Unified Sim Controller Board
Engineer(s):	Joesphan Lu
Revision:	1.0
Release Date:	9/22/2020
Github:	https://github.com/joesphan/Unified-Sim-Controller

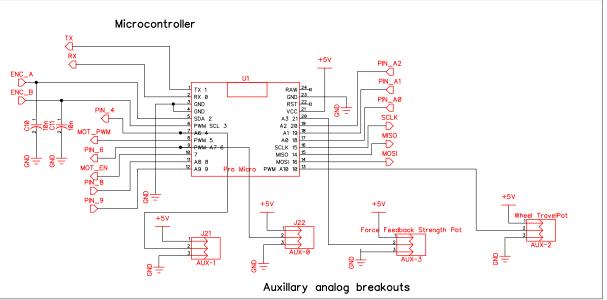
The -10V rail must be at least -5V for the op-amp to be able to output 0V.

recalculate r11 for different voltage
